PUBLIC HEARING/WORKING SESSION MEMORANDUM

PETITION #299-21

131 Rumford Avenue

Subject: **Transportation Peer Review –
Proposed Marijuana Use
131 Rumford Avenue
Newton, Massachusetts**

Modified proposed front façade

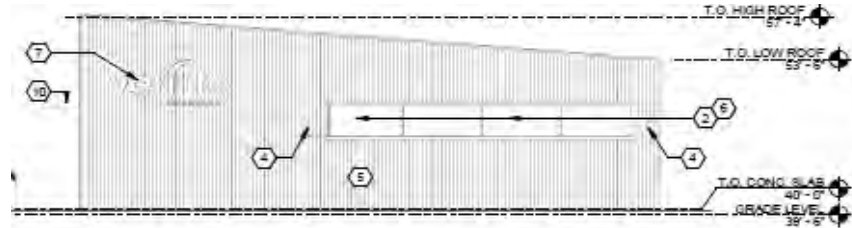
In response to comments made at the previous public hearing, the petitioner has provided a modified building design, including the structure's Rumford Avenue (north) façade. The current design includes a band of fenestration on that façade's center and right. The wall-mounted signage has been modified as well.

The Planning Department notes that the proposal would still require relief from the requirement that structure provide at least 25 percent transparency along the building's front façade at ground level.
